Subject: Applicant's Response to Data Requests, Set 2A (#155-172)
Rio Mesa Solar Electric Generating Facility (11-AFC-04)

Applicant's Response to Data Requests, Set 2A (Nos. 155-172)

**Rio Mesa Solar Electric
Generating Facility
(Rio Mesa SEGF)**

(11-AFC-04)

URS **SCALE: 1" = 527' (1:6,600)** **CREATED BY: PM** **DATE: 6/15/2012** **FIG. NO. 162b-1**
SCALE CORRECT WHEN PRINTED AT 36x48 **PM: AL** **PROJ. NO: 27652105.00304**

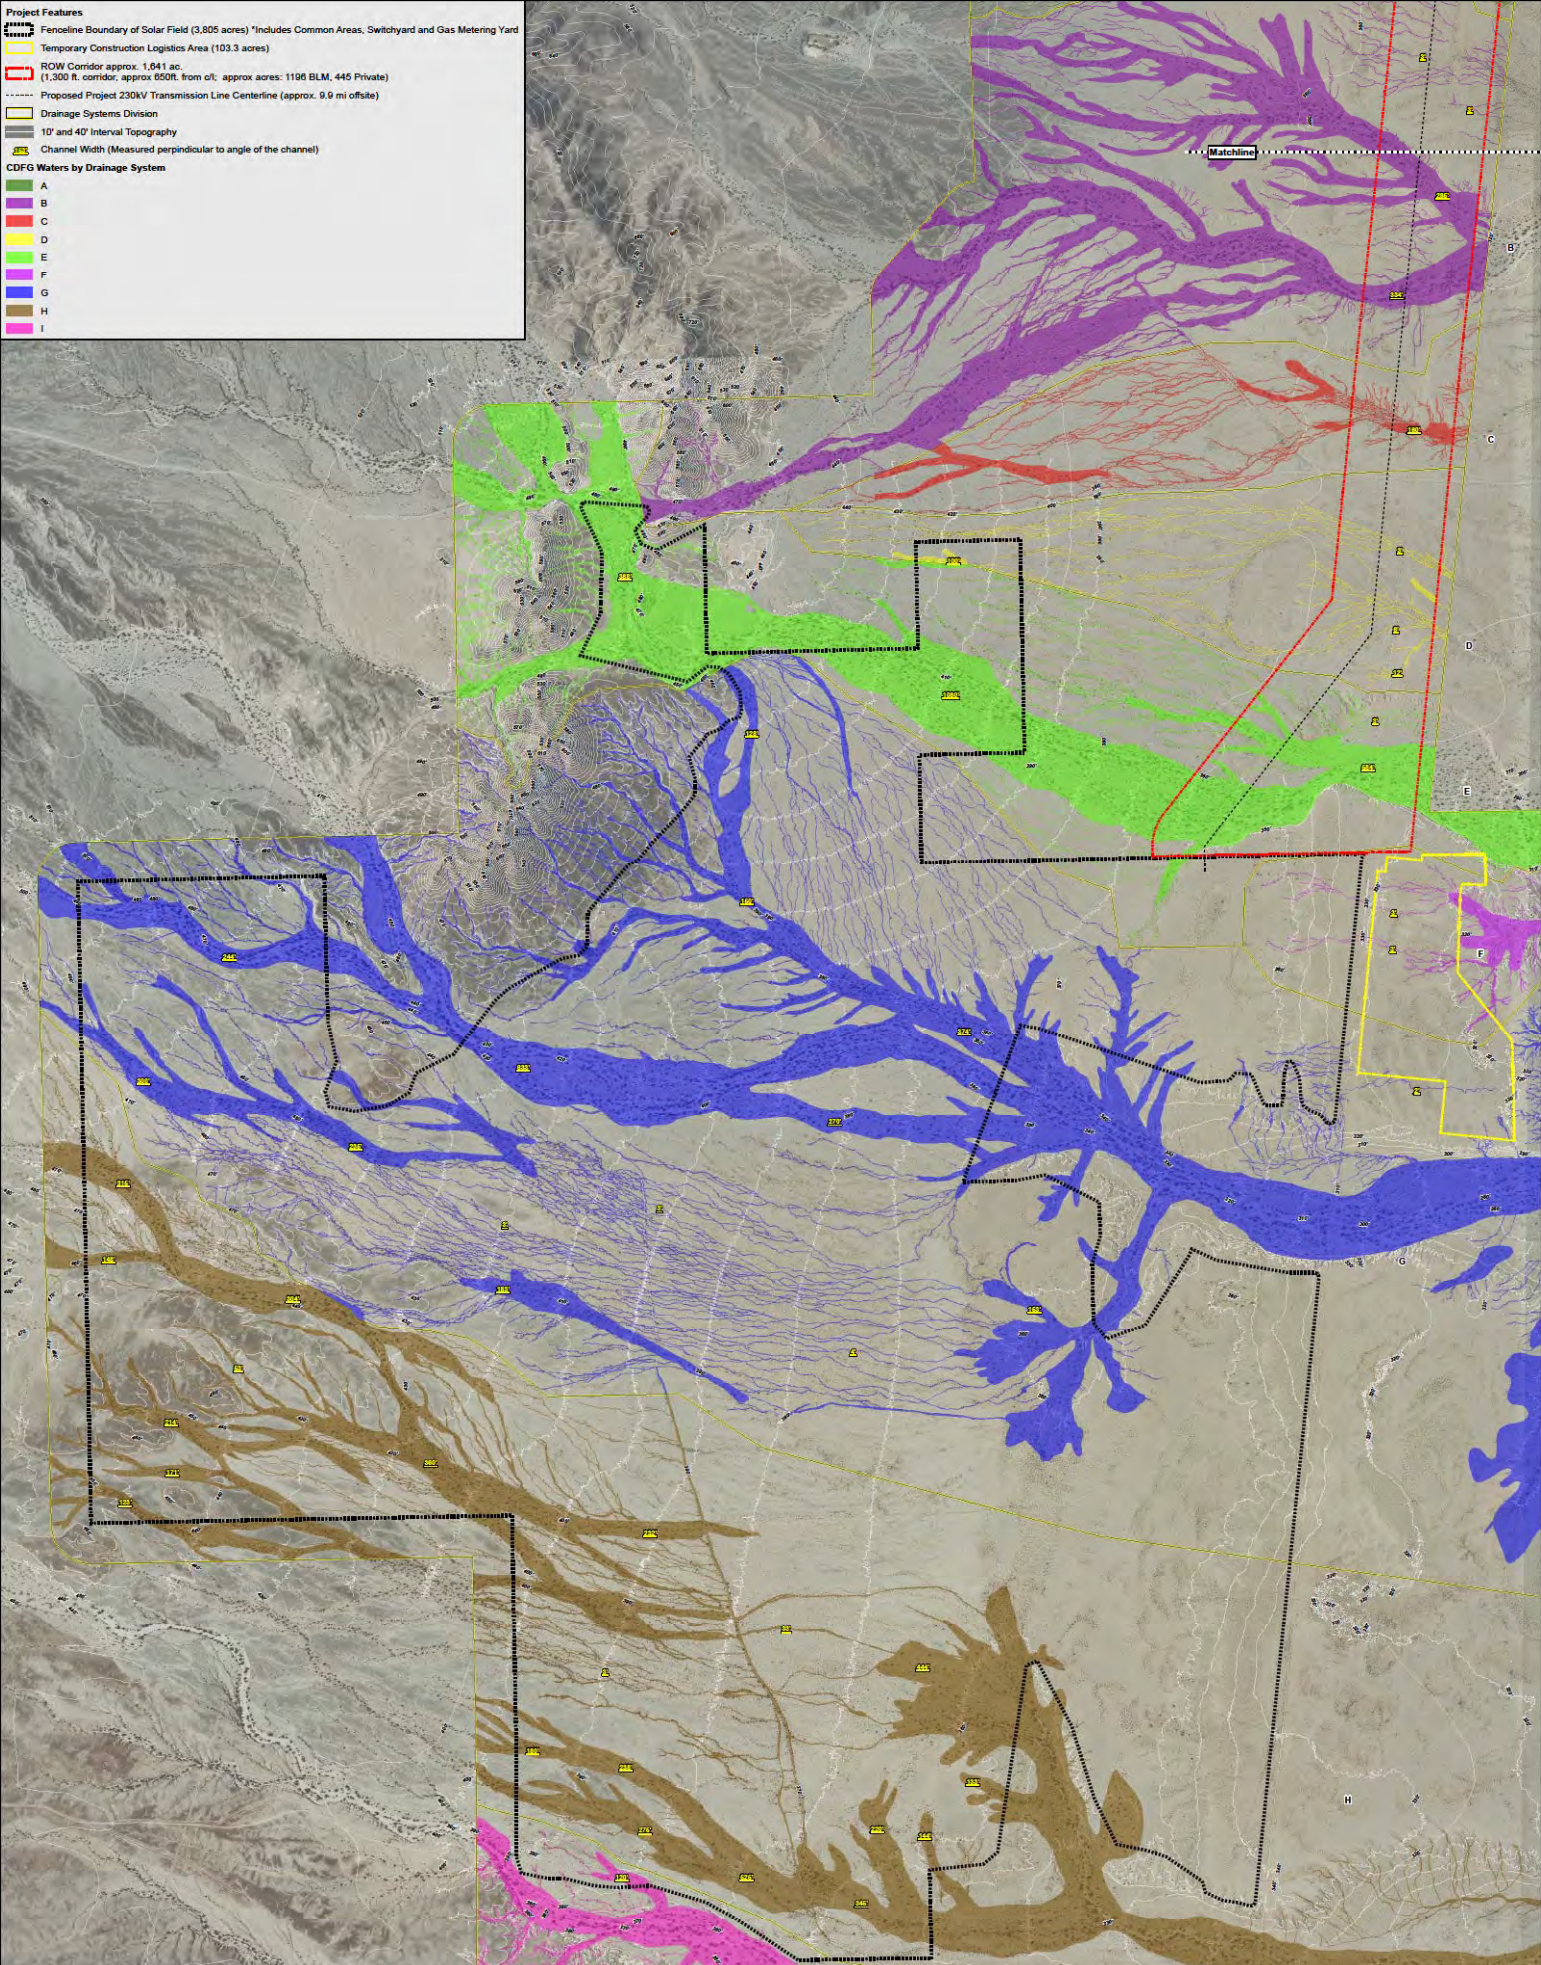
162. *In a 1:3,600 or finer scale map, please show:*

- a. The project footprint and outline of any project related disturbance areas; and
- b. Numerical values of elevation contour lines and widths of jurisdictional features.

162b: Two e-sized plots (Attachment 162b-1 covering the main project site and Attachment 162b-2 covering the transmission line corridor) of the numerical values of elevation contour lines and widths of jurisdictional features.
